**CHANGE
ORDER**

PROJECT:	Washoe County – Nevada Shared Radio System	CHANGE ORDER NO.:	8
		DATE:	09/22/2020
SELLER:	Harris Corporation Communication Systems Segment	CONTRACT DATE:	September 27, 2018
SELLER ADDRESS:	221 Jefferson Ridge Parkway Lynchburg, VA 24501

Change Order No. 8 Detailed Description

Exhibit A, Exhibit 1: Statement of Work, System Description, pages 32-35**Microwave System**

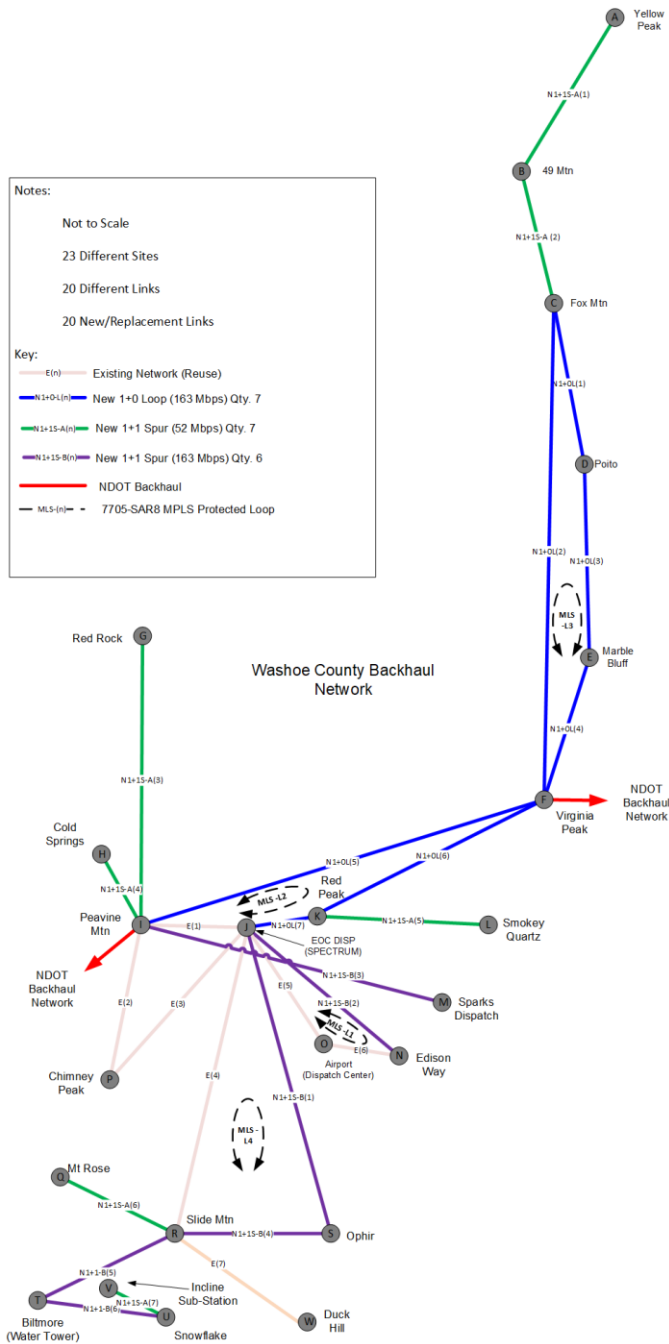
- (b) The Original Microwave Infrastructure Scope of Work is hereby deleted in its entirety and replaced with the Microwave Infrastructure Scope of Work, Revision 1, attached hereto and incorporated herein as Exhibit B, Schedule 2.

Harris will design and implement the new Washoe County microwave network that will provide high-speed wireless Ethernet transmission via the Nokia 7705 SAR-8 MPLS router installed at each Washoe County site. The new Washoe County microwave network will interconnect with the NDOT microwave network to form the NSRS backhaul. Harris will perform all services to implement all new equipment that includes microwave dishes, waveguide, radios, dehydrators, Network Management System and MPLS routers to provide network connectivity between the RF sites, cores, and existing PSAPs in Washoe County. Harris has reviewed the existing Comsearch Microwave Path Data Sheet provided by Washoe County and have used this data along with the selected RF sites in Washoe County to provide a microwave backhaul network solution that will interconnect to the NDOT microwave network which forms the NSRS. The new Washoe County microwave network solution comprises of 20 links which is a combination of loop-protected microwave links and monitor hot standby (MHSB) links. These links will interconnect the cores, RF sites and PSAPs to the NSRS. Each link will be designed with a path availability of 99.999% based on the receive threshold to provide the required link bandwidth.

Included in Nokia Quote	Designation	Site A Name	Site B Name	Bandwidth Proposed	Bandwidth New Request
Yes	N1+0L(1)	Poito	Fox Mtn	25	163
Yes	N1+0L(2)	Virginia Peak	Fox Mtn	25	163
Yes	N1+0L(3)	Poito	Marble Bluff	25	163
Yes	N1+0L(4)	Virginia Peak	Marble Bluff	25	163
Yes	N1+0L(5)	Peavine Mtn	Virginia Peak	166	163
Yes	N1+0L(6)	Virginia Peak	Red Peak	166	163
Yes	N1+0L(7)	Spectrum	Red Peak	166	163
Yes	N1+1S-A(1)	49 Mtn	Yellow Peak	25	52
Yes	N1+1S-A(2)	Fox Mtn	49 Mtn	25	52
Yes	N1+1S-A(3)	Red Rock	Peavine Mtn	Not proposed	52
Yes	N1+1S-A(4)	Peavine Mtn	Cold Springs	25	52
Yes	N1+1S-A(5)	Red Peak	Smokey Quartz	52	163
Yes	N1+1S-A(6)	Mt Rose	Slide Mtn	25	52
Yes	N1+1S-A(7)	Snowflake	Incline	25	52
Yes	N1+1S-B(1)	Spectrum	Ophir Peak	Not proposed	163
Yes	N1+1S-B(1)	Peavine Mtn	Sparks Dispatch	25	163
Yes	N1+1S-B(2)	Edison Way	Spectrum (EOC_DISP)	Not proposed	163
Yes	N1+1S-B(4)	Slide Mtn	Ophir Peak	166	163
Yes	N1+1S-B(5)	Biltmore	Slide Mtn	25	163

Yes	N1+1S-B(6)	Snowflake	Biltmore	25	163

The new Washoe County microwave network will include the Nokia 7705 SAR-8 MPLS routers for routing all packets between microwave sites, core locations and between NDOT and Washoe County microwave networks. In the event of a microwave path failure within a microwave loop, the 7705 SAR-8 will automatically reroute traffic to the opposite direction of the network. For RF sites that are connected by microwave spurs, a 1+1 MHSB radio will be installed to increase the reliability of the link. Harris has designed the microwave network based on the topology provided in Figure 23 below. The main microwave loop for interconnecting the two core sites in Washoe County consists of a 163 Mbps 1+1MHSB link with 7705 SAR08 MPLS backup loop protection using available bandwidth of existing links. The two cores are located at the EOC Dispatch and Edison Way locations. The northern loop and all spur sites will have links that support 52 Mbps radios. The Washoe County microwave network will interconnect with the NDOT microwave solution which share network nodes at Peavine Mtn and Virginia Peak site locations. Harris will coordinate with NDOT to support the routing of packets between the cores, RF sites and PSAPs located on the Washoe County side and the NDOT side of the NSRS.

The existing microwave links in Washoe County were considered and are based mainly on Nokia (formerly Alcatel) DS1 microwave circuits. Analysis of the existing microwave paths that will be reused are limited in bandwidth due to the nature of the existing DS1 signaling and will need to be replaced with all new Ethernet based radios to meet the NSRS bandwidth requirements. The existing DS1 links will remain operational until full cutover to the new NSRS. At that point, the equipment for ten existing links that are being replaced will be removed only.
